Contract #: **04-0120E4**
Cty **SF** Rte **80** PM **13.4/13.8.**
File # **45.25 B****QUALITY ASSURANCE - NONCONFORMANCE REPORT**Location: **Ingleside, Texas**

NCR #103

Subject: Response to Submittal No. 1105, Revision No. 00 (KOS Response to METS NCR 103)

KFM SUBMITTAL 1105-00 –KIEWIT OFFSHORE SERVICES (KOS) RESPONSE TO NONCONFORMANCE REPORTS 103

Below are two digital pictures illustrating end plate P156-1 built up by welding and the failure to use runoff tabs. On the left is a similar weld joint prior to welding.

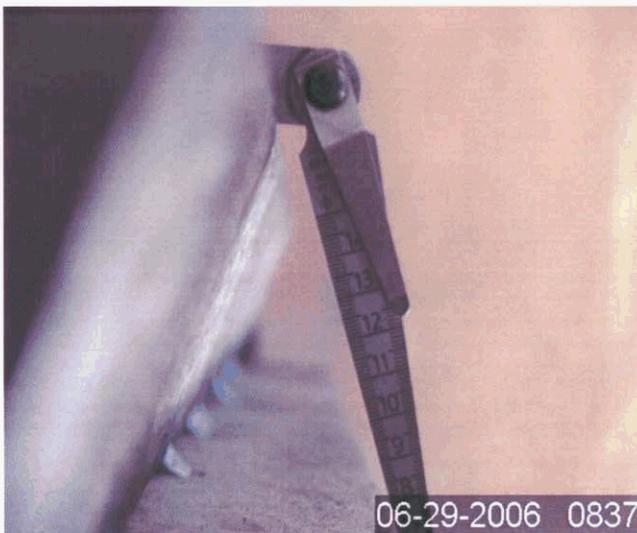
- 1) KOS Quality Control (QC) allowed KOS to deviate from the approved shop drawings without an approval from the Engineer. KOS altered a joint configuration of end plate P156-1 from an overhead to a flat position weld.
- 2.) KOS Quality Control allowed KOS production to butter end plate P156-1 without the use of weld tabs.
- 3.) Dimensions of the areas buttered on end plate P156-1 are as follows: approximately 60 millimeters in height and approximately 25 millimeters in depth.

Applicable reference: 1) AWS D1.5 2002 section 2.1.3 “Contract design drawings shall specify the effective weld length and, for partial joint penetration (PJP) groove welds, the required weld size, as defined in 2.3. Shop or working drawings shall specify the groove angles (α and β) and depths (S) applicable to the weld size (E) required for the

welding processes and position of welding to be used.” 2) AWS D1.5 2002 section 3.12.1 “Welds shall be terminated at the end of a joint in a manner that will ensure sound welds. Whenever possible, this shall be done by the use of weld tabs (extension bars and runoff plates) placed in a manner that will duplicate the joint detail being welded.” 3) Section 3.3.4.2 “Root openings larger than those allowed in 3.3.4.1 may be corrected by welding only with the approval of the engineer.”

The AWS D1.5-2002 Code Section 3.3.4.2 requires root openings larger than those allowed in Section 3.3.4.1 to be corrected by welding, only with the approval of the Engineer. As stated in the Contractor's response dated November 15, 2006, the Contractor elected to proceed with buttering the weld joint of end plate P156 in order to modify the joint configuration from a double bevel a single bevel without approval by the Engineer. Although the Department approved the Contractor's request to make this repair on July 28, 2006, the Contractor was reminded of the contractual requirement to receive prior Engineer approval. Since that time, the Contractor has complied with the specification and no further instances of this issue have occurred.

Additionally, The AWS D1.5-2002 Code, Section 3.12.1 requires welds to be terminated at the end of a joint in a manner that will ensure sound welds. Furthermore, the D1.5 Code requires this be done by the use of weld tabs (extension bars and runoff plates) placed in a manner that will duplicate the joint detail being welded. Although the Contractor's response indicates they used a "weld dam" in lieu of weld tabs, METS informed the Contractor this would not be an acceptable alternative. As requested by the Department, the Contractor did examine the 100% of the repaired area with Ultrasonic

and Magnetic Particle Testing. The results presented in the Contractor's response show the welds to be clear of rejectable defects. No further instances of this issue have been documented by METS.

Based on the comments above, METS considers NCR 103 to be closed at this time.
